Form 3160-5 (June 2019)

| BURE   | EAU OF LAND MANAGEMENT  | N N                      | NMNM114985                            |  |  |  |
|--|---|--------------------------|---------------------------------------|--|--|--|
| . Type of Well  Oil Well  Gas W  | ell Other   |                          | 8. Well Name and No.                  | DRIVER 14 FED COM/701H                   |  |  |
| is ready for final inspection.)  EOG respectfully requests an a  DRIVER 14 FED COM 711H (F | ices must be filed only after all requirement amendment to our approved APD for this FKA 701H) API #: 30-025-52925            | is well to reflect the   |                                       | he operator has detennined that the site |  |  |
| Change name from DRIVER 14   | 4 FED COM 701H to DRIVER 14 FED (   | COM 711H.                |                                       |  |  |  |

#### WELL LOCATION AND ACREAGE DEDICATION PLAT

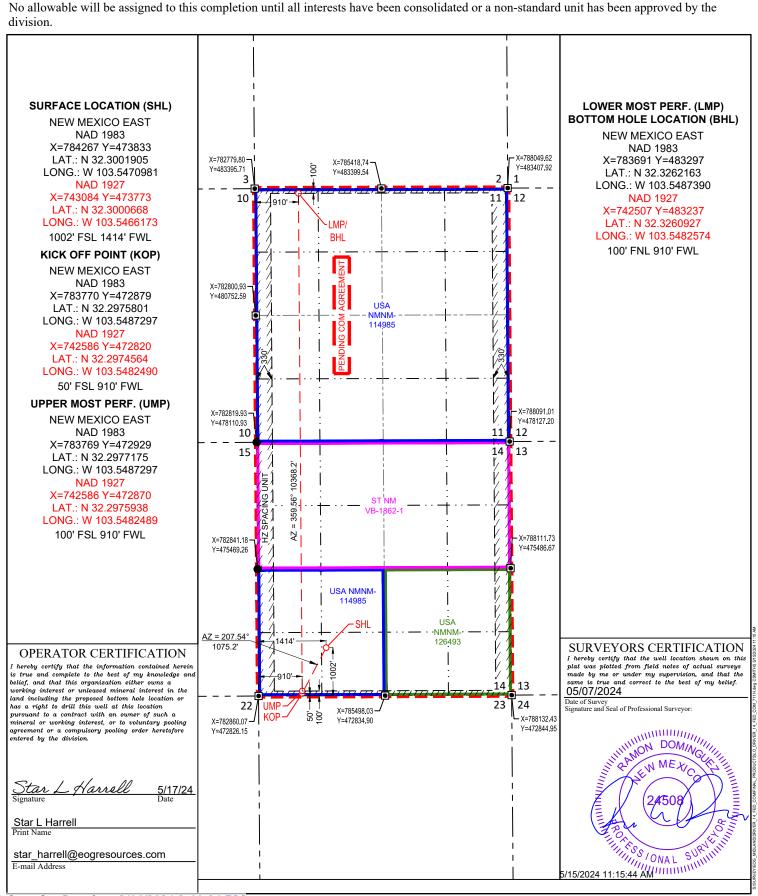
| BURE   | EAU OF LAND MANAGEMENT  | N N                      | NMNM114985                            |  |  |  |
|--|---|--------------------------|---------------------------------------|--|--|--|
| •  | 3-E, Sec 11, 100' FNL, 825' FWL, LEA<br>O' FNL, 910' FWL, LEA Co., N.M.   | Co., NM,                 |                                       |  |  |  |

Update HSU to 1280 acres.

| A               | PI Number |          | Pool Code Pool Name         |                                 |            |          |                   |               |                |        |
|-----------------|-----------|----------|-----------------------------|---------------------------------|------------|----------|-------------------|---------------|----------------|--------|
| 1280.00         |           |          | PENDING COM AGREEMENT       |                                 |            |          |                   |               |                |        |

#### **DRIVER 14 FED COM 711H**

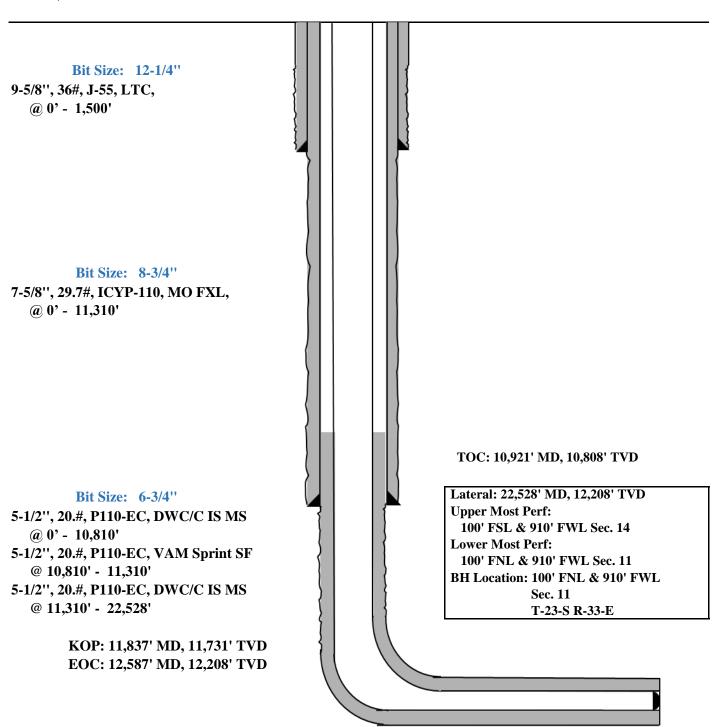
#### **CASING PROGRAM:**

Variance is requested to waive the centralizer requirements for the 7-5/8" casing in the 8-3/4" hole size. An expansion additive will be utilized, in the cement slurry, for the entire length of the 8-3/4" hole interval to maximize cement bond and zonal isolation.

Variance is also requested to waive any centralizer requirements for the 5-1/2" casing in the 6-3/4" hole size. An expansion additive will be utilized, in the cement slurry, for the entire length of the 6-3/4" hole interval to maximize cement bond and zonal isolation.

Variance is also requested to waive the annular clearance requirements for the 5-1/2" casing by 7-5/8" casing annulus to the proposed top of cement.

1002' FSL Revised Wellbore KB: 3703'

### **Design B CASING PROGRAM:**

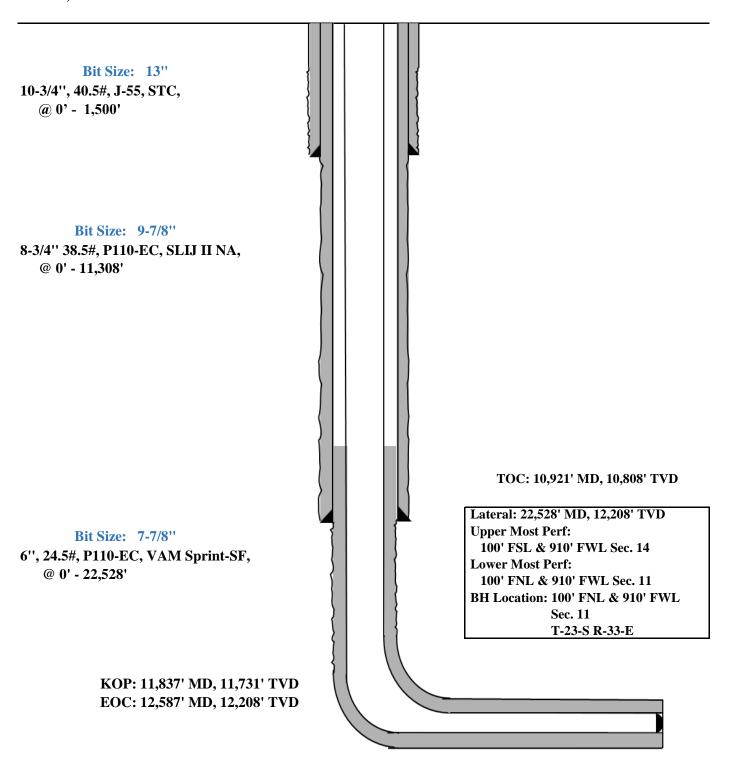
Variance is requested to waive the centralizer requirements for the 8-3/4" casing in the 9-7/8" hole size. An expansion additive will be utilized, in the cement slurry, for the entire length of the 9-7/8" hole interval to maximize cement bond and zonal isolation.

Variance is also requested to waive any centralizer requirements for the 6" casing in the 7-7/8" hole size. An expansion additive will be utilized, in the cement slurry, for the entire length of the 7-7/8" hole interval to maximize cement bond and zonal isolation.

Variance is also requested to waive the annular clearance requirements for the 6" casing by 8-3/4" casing annulus to the proposed top of cement.

Figure 1: Cameron TA Plug and Offline Adapter Schematic

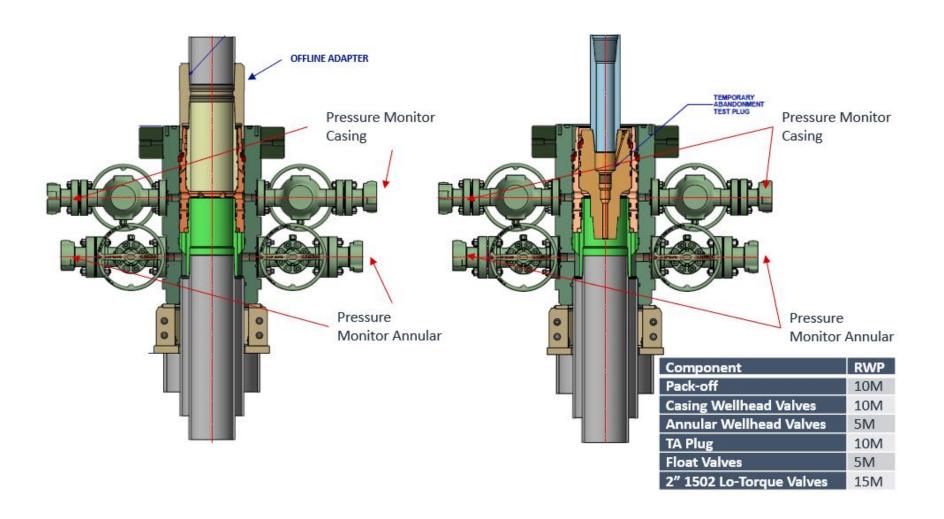
- c. Return line schematics can be seen in Figure 3.
- 10. Remove TA Plug from the casing.
- 11. Install offline cement tool.
  - a. Current offline cement tool schematics can be seen in Figure 1 (Cameron) and Figure 2 (Cactus).

Figure 4: Rig Placement Diagram

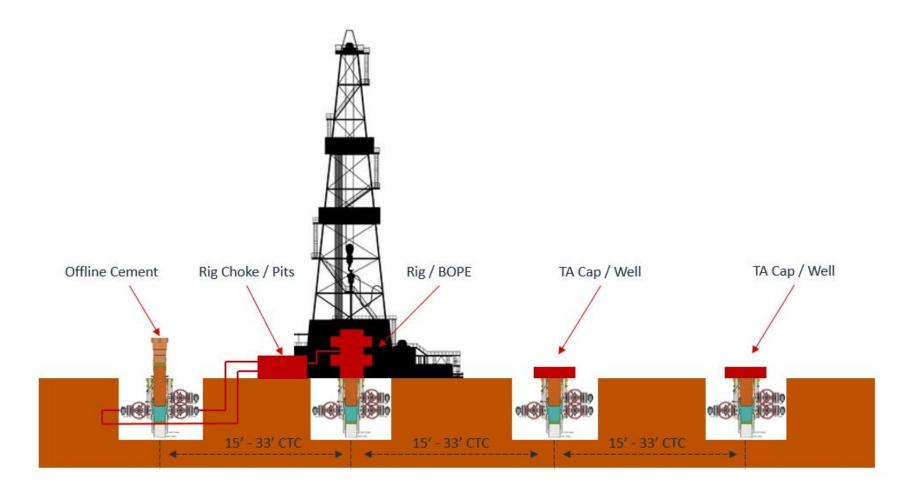
- e. Diagram for rig positioning relative to offline cementing can be seen in Figure 4.
- 9. Rig up return lines to take returns from wellhead to pits and rig choke.
